Kill Switch Wiring

Kohler Engines Baja Team

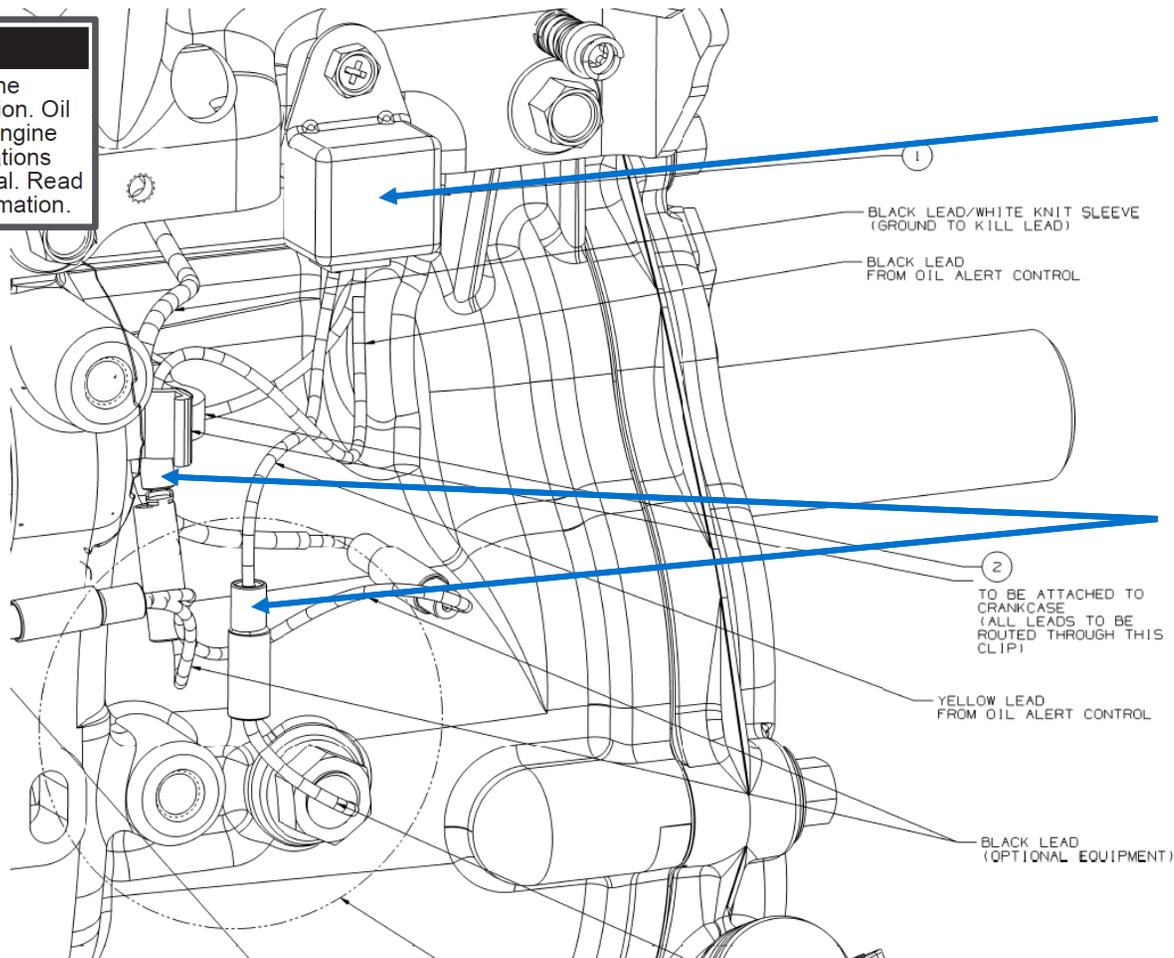
Disconnect the two wires from the switch at the Carburetor

Pull wires from the carburetor to the back of the engine carefully

Connect the two wires to the two required Normally open Kill Switches and wire them in parallel

With this modification, the Red lever will not shutdown engine via spark but it will turn off fuel flow to the carburetor.
